SECTION 00 9111
ADDENDUM NUMBER 01

DATE: August 19, 2024

PROJECT: S-29 Miller Armory Latrine Addition

PROJECT NUMBER: 2112209640

WALL TYPE M#A
 3" = 1'-0" 0" 6"

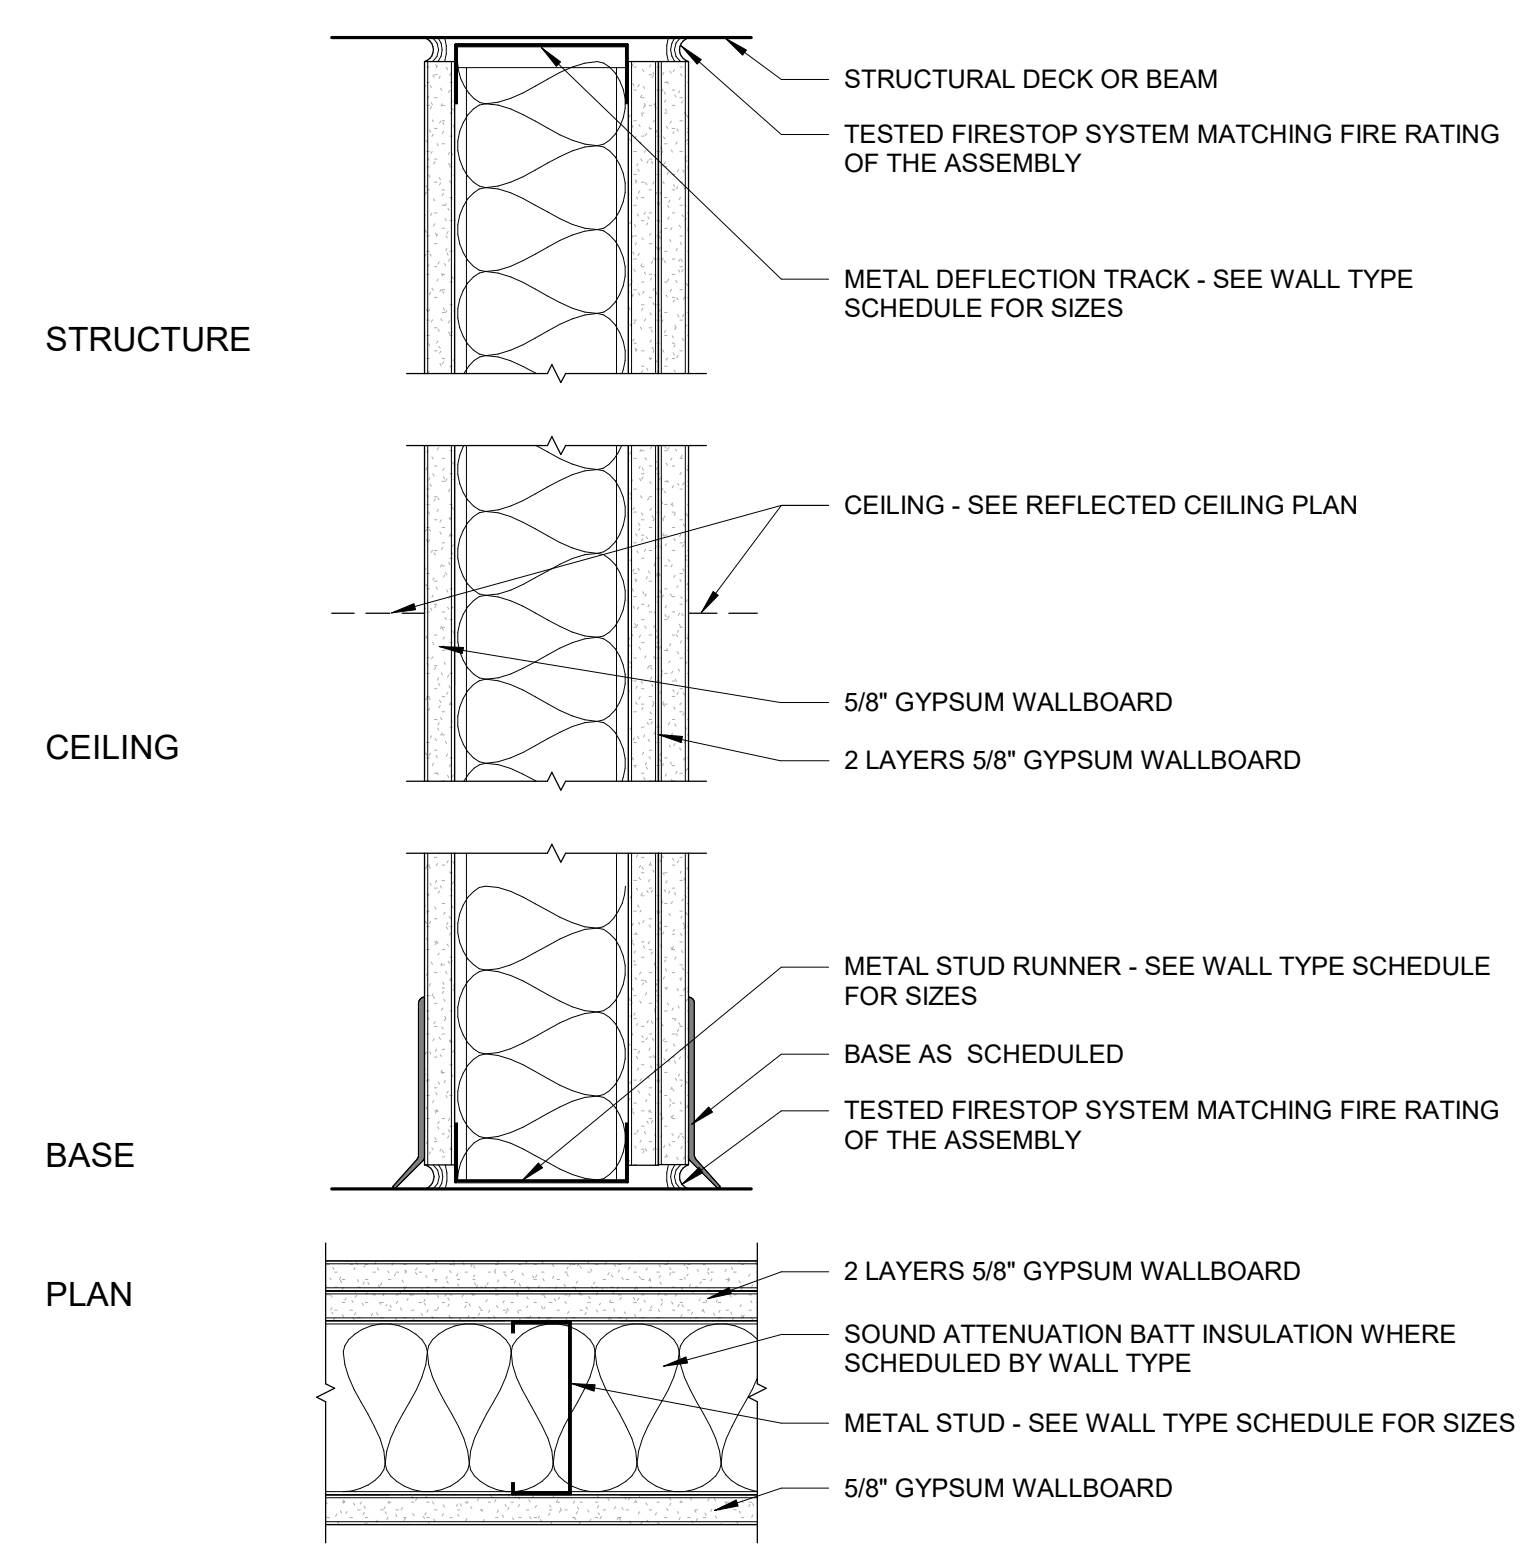
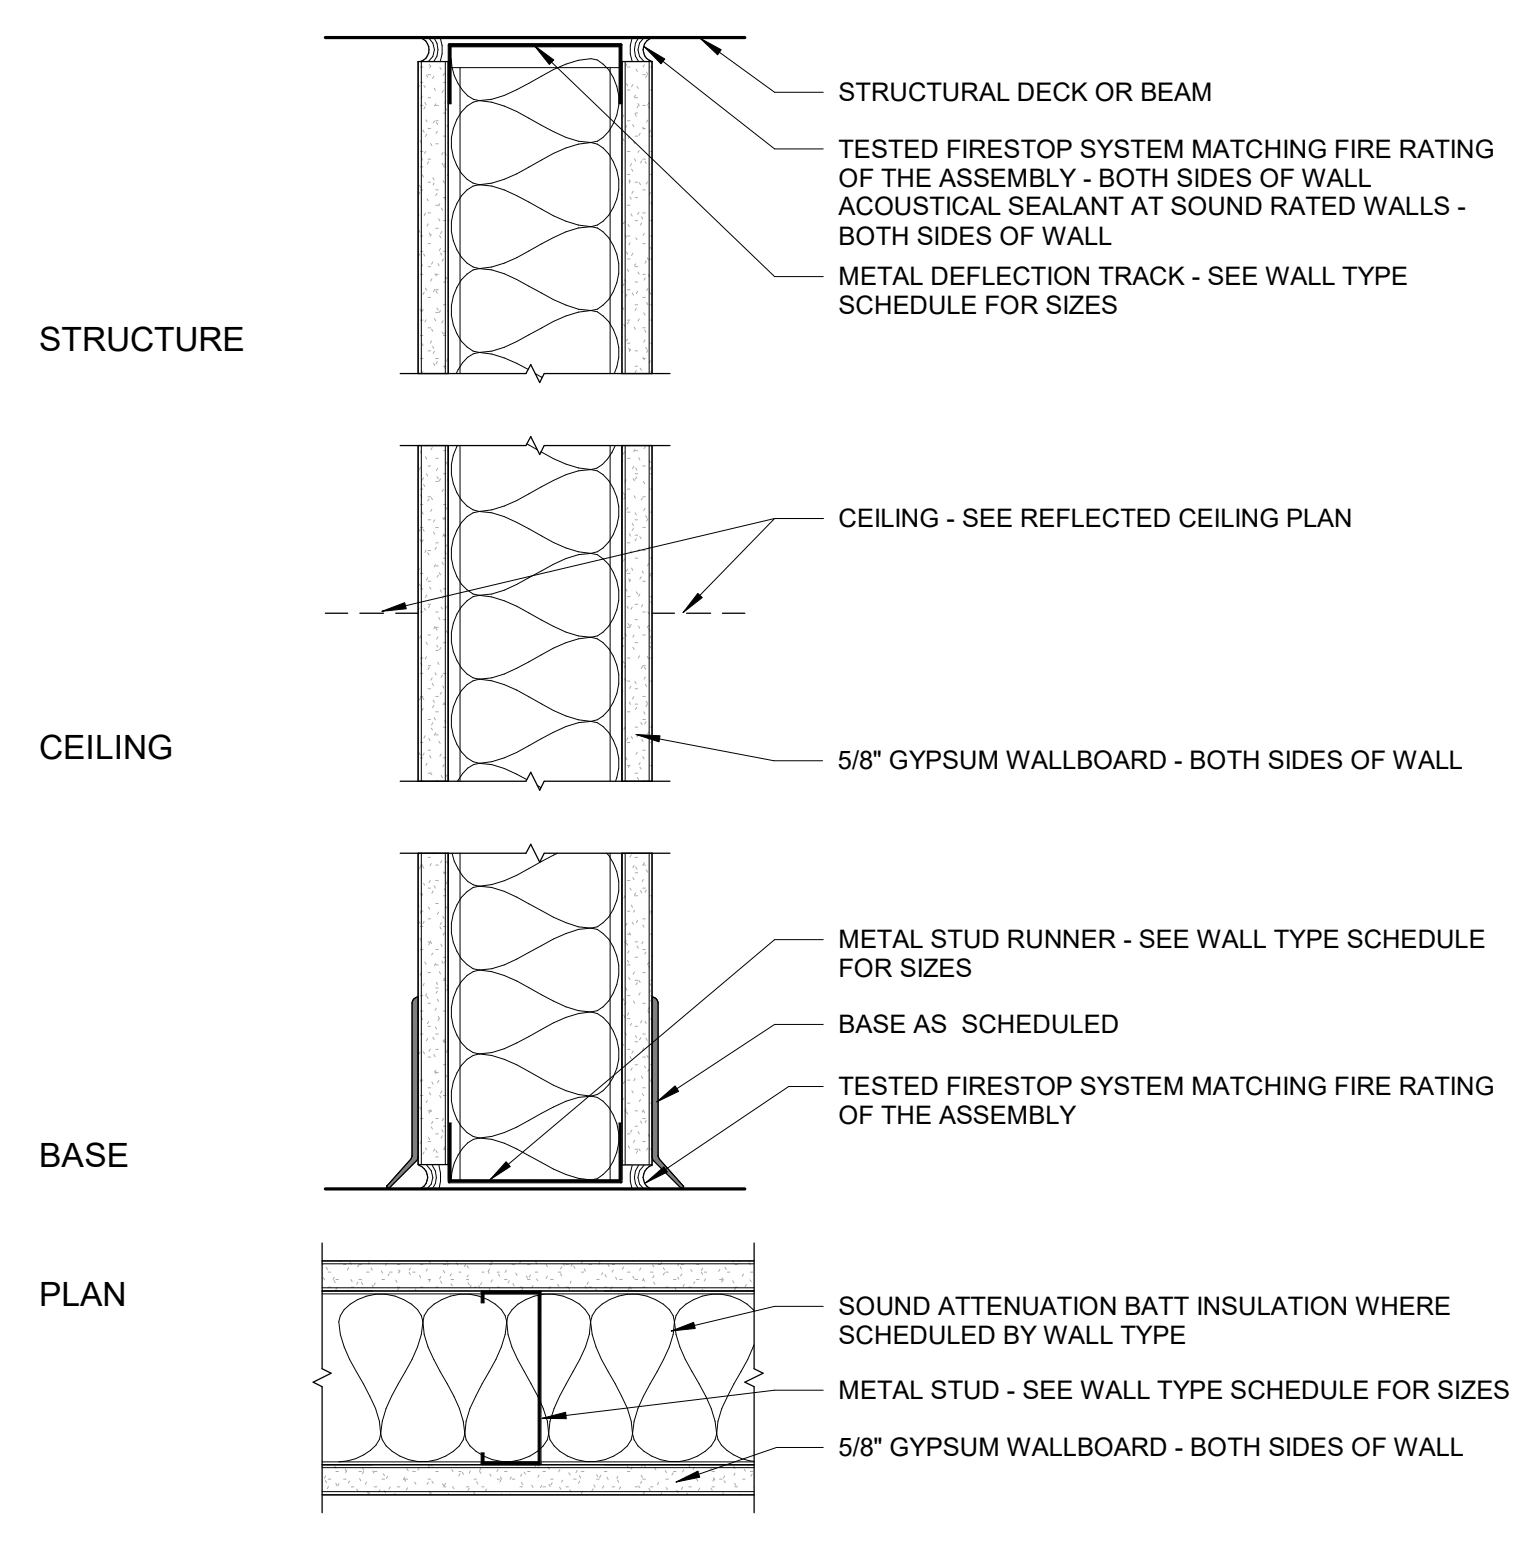
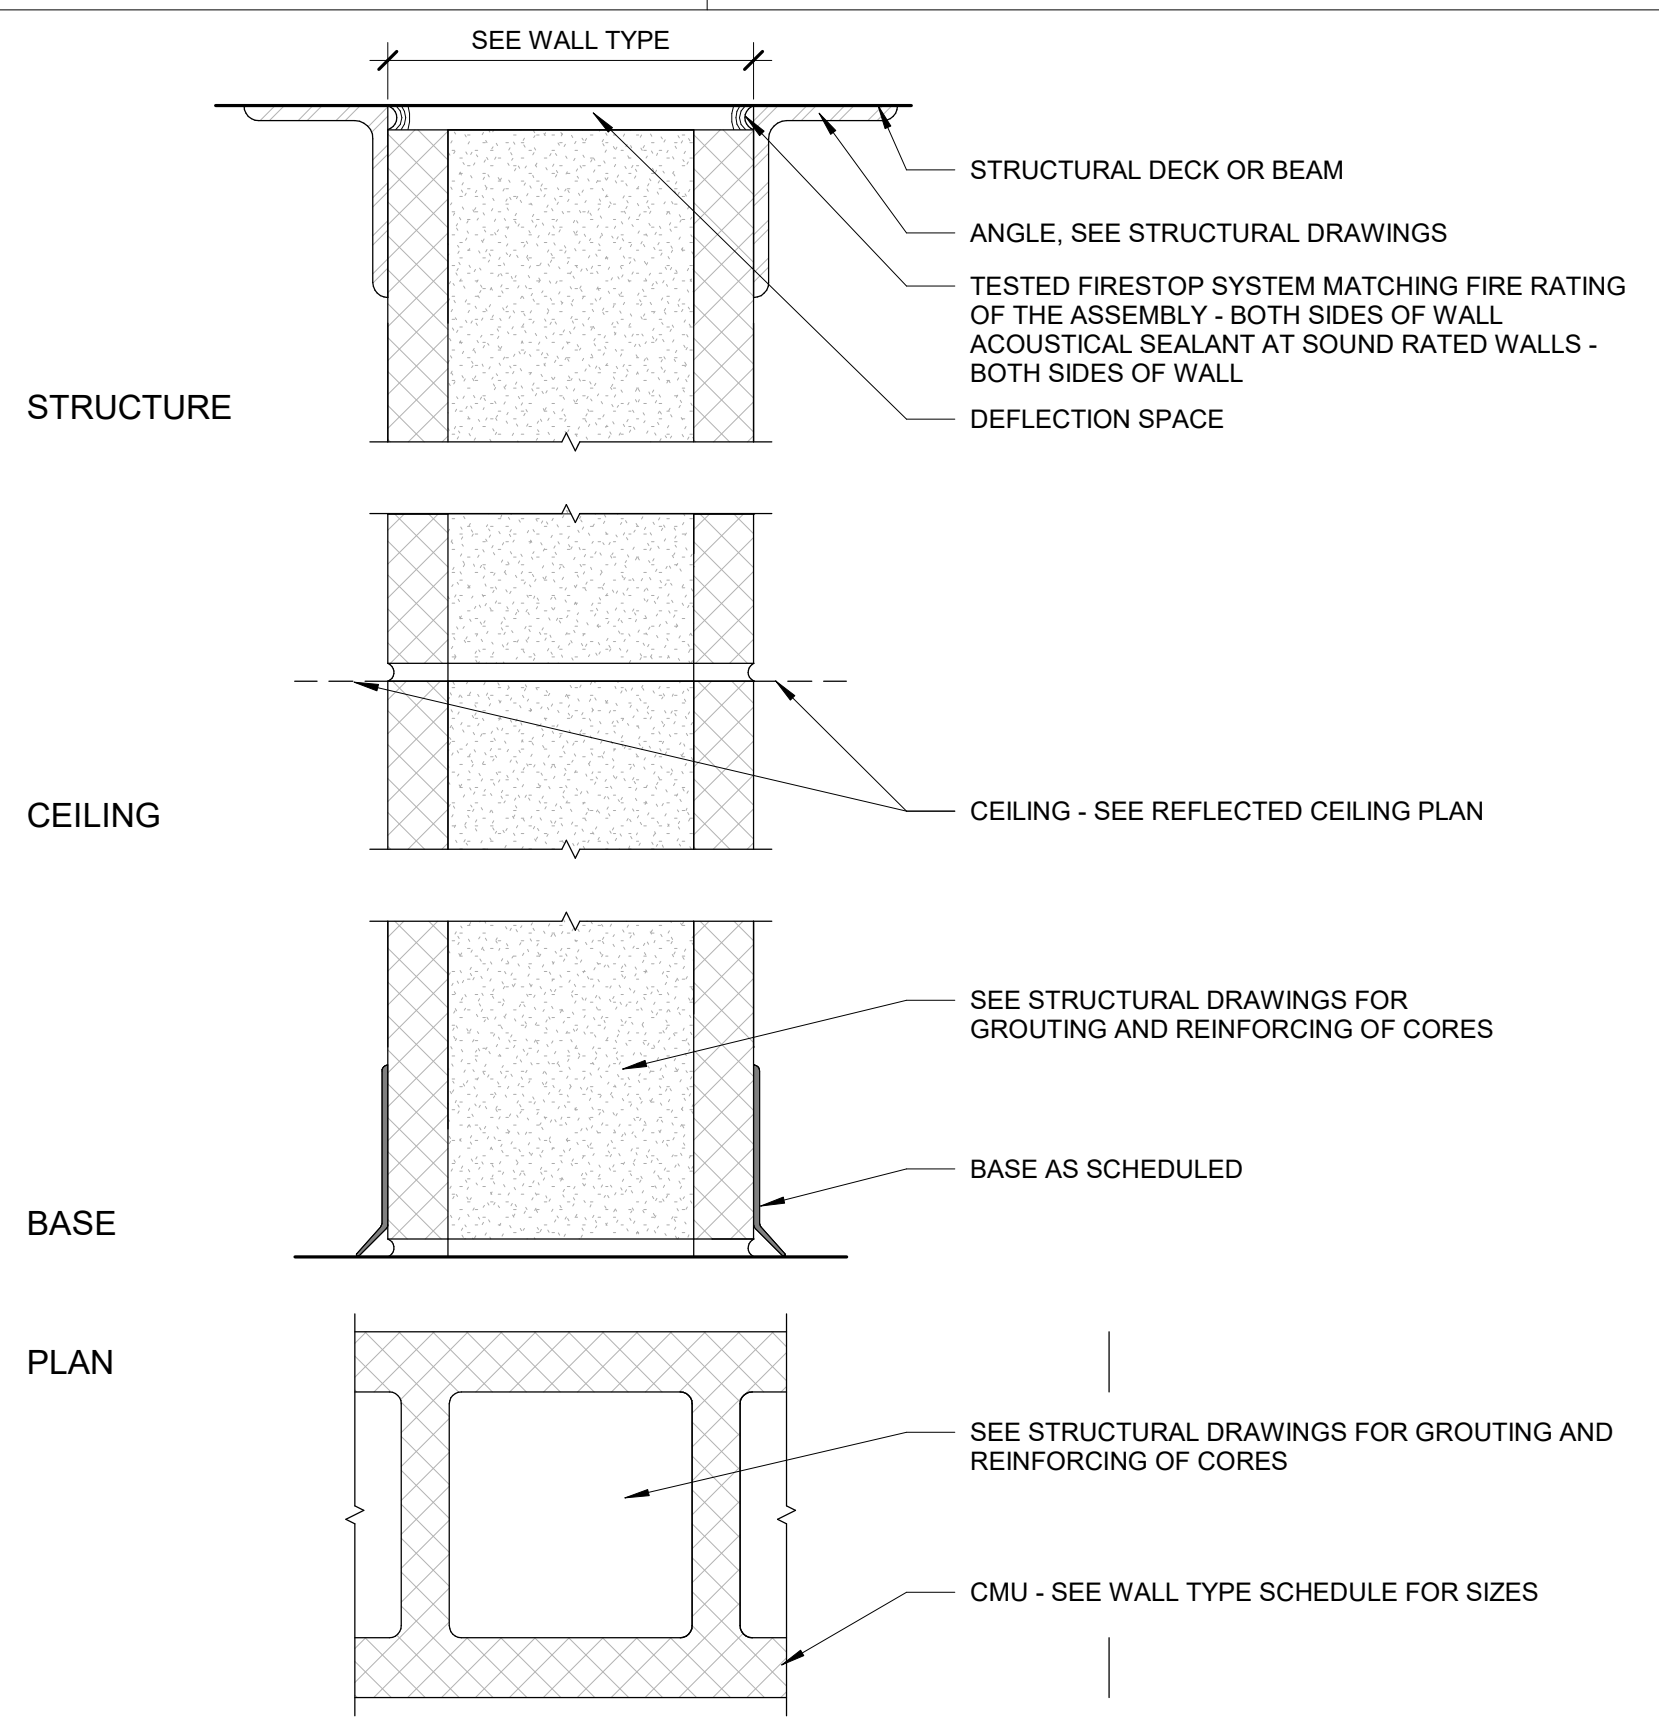
1. M#A WALL TYPES SCHEDULE: **REVISE** “Wall type schedule to show the 2 HR fire rated wall and UL number.”
